UNITED STATES PATENT AND TRADEMARK OFFICE

APPLICATION NO.	FILING DATE	FIRST NAMED INVENTOR	ATTORNEY DOCKET NO.	CONFIRMATION NO.
10/517,610	09/09/2005	Fahri Keretli	263067US6XPCT	7963
22850 7590 12/10/2008 OBLON, SPIVAK, MCCLELLAND MAIER & NEUSTADT, P.C. 1940 DUKE STREET ALEXANDRIA, VA 22314				
EXAMINER BARROW, AMANDA J				
ART UNIT 4111		PAPER NUMBER		
NOTIFICATION DATE 12/10/2008		DELIVERY MODE ELECTRONIC

Office Action Summary

FIG_1

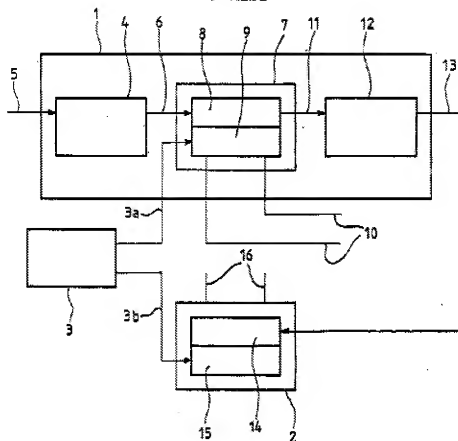
5. Regarding claim 1, Boudjemaa teaches a method for starting a fuel cell stack (a device for supplying hydrogen to a fuel cell (1)) as is illustrated in Figure 1 below comprising: a plurality of cells (primary fuel cell (2) and auxiliary fuel cell stack (7)) supplied by a reformer (4). When the reformer is cold the first subassembly (auxiliary fuel cell stack (7)) is supplied with reformates, and then when the reformer is hot, the first and second subassemblies of cells (primary fuel cell (2) and auxiliary fuel cell stack (7)) of the fuel cell stack (a device for supplying hydrogen to a fuel cell (1)) are supplied with reformates. The cells of the first subassembly (auxiliary fuel cell (7)) are optimized for operation with a cold reformer and the cells of the second subassembly (primary fuel cell (2)) are optimized for operation with a hot reformer (pg. 2, paragraphs 23-31).

6. Regarding claim 1, for clarity, a "cold reformer" is defined as producing reformates that are hydrogen (H₂) lean and carbon monoxide (CO) rich and has not reached its optimal operating condition, while a "hot reformer" is defined as producing reformates that are H₂ rich and CO lean and has reached its optimal operating condition. This information was disclosed by the applicant.

Regarding claim 2, Boudjemaa teaches a method in which the cells of the second subassembly (primary fuel cell (2)) are supplied when the said cells are at an appropriate operating temperature (pg. 2, paragraphs 23-31).

Regarding claims 1 and 2, this rejection could be overcome if “only” was inserted into claim 2 so that claim 2 read, “A method according to claim 1, in which the cells of the second subassembly are only supplied when the said cells are at an appropriate operating temperature.”

FIG. 3

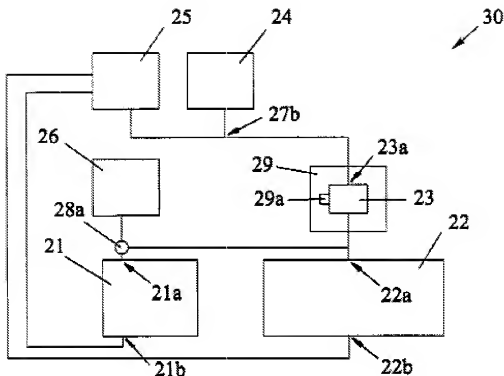
9. Regarding claim 4, Tillmetz teaches a fuel-cell stack (fuel cell system (30)) illustrated below in Figure 3 comprising: a plurality of cells (first fuel cell stack (21) and second fuel cell stack (22)) and a reformer (23) capable of supplying hydrogen from a hydrocarbon fuel, with the first subassembly of cells (first fuel cell stack (21)) being optimized to operate with a cold reformer and a second subassembly of cells (second fuel cell stack (22)) being optimized to operate with a hot reformer. (Column 6, lines 63-67; Column 7, lines 1-19). The phrases "optimized to operate with a hot (cold) reformer" are a functional limitation and impart no structural limitations (see MPEP 2114), and can therefore be interpreted to mean that the reformer is fluidly connected to

both assemblies.

10. Regarding claim 4, Tillmetz also teaches means for supplying the second subassembly of cells as a function of the reformer temperature:

"...the start-up period is typically completed when the temperature of a component in the fuel cell system reaches a pre-determined threshold value. Thus, the temperature parameter of the component may be monitored and used to trigger an end to the start-up period of the system. Since the operating temperature of the reformer is generally indicative of its ability to produce a satisfactory reformed fuel stream, its temperature may be used as the trigger in preferred embodiments" (Column 4, lines 26-34).

Regarding claim 5, Tillmetz teaches a system that can supply the second subassembly of cells (fuel cell stack 2 (22)) as a function of the temperature of the said

second subassembly as, "Alternatively, the temperature of the second portion of fuel cells may be used as the trigger" (Column 4, lines 35-36). This is a direct continuation of the preceding quote (Column 4, lines 26-34).
